MEMORANDUM

Subject: Recommendation of locations for multi-port well installations, Containment Area, Olin Chemical Superfund Site, Wilmington, MA.

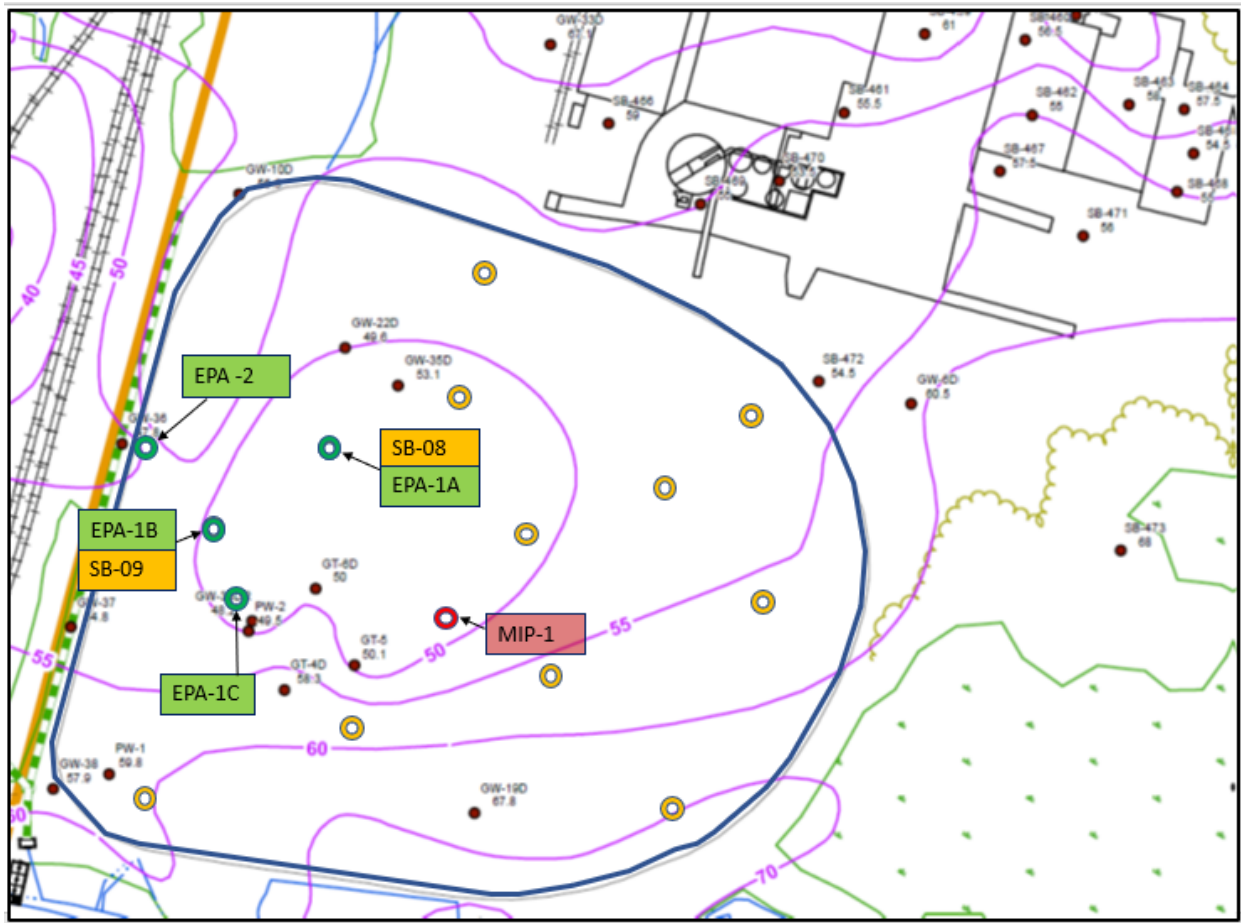
The following figure and associated table indicate two locations within the Containment Area at the Olin Chemical Superfund Site, Wilmington, MA. The locations have been prioritized based on EPA's knowledge and analysis of site conditions to date. A site visit on November 4 also contributed to EPA's current recommendations.

ID	Location	Comment
EPA-1A	SB-08	See comments below. EPA-1 to be selected from deepest confirmed bedrock elevation encountered at 3 locations: SB-08, -09, and vicinity of PW-2
EPA-1B	SB-09	A/A
EPA-1C	PW-2	Locate proximal to PW-2 is no deeper location identified at SB-08 or -09. Consideration should be given to a location near PW-2 in order to provide an analogue for subsurface conditions nearest to PW-2

EPA-2	GW-36	Deepest part of basin in downgradient location on potential pathway in bedrock
-------	-------	--
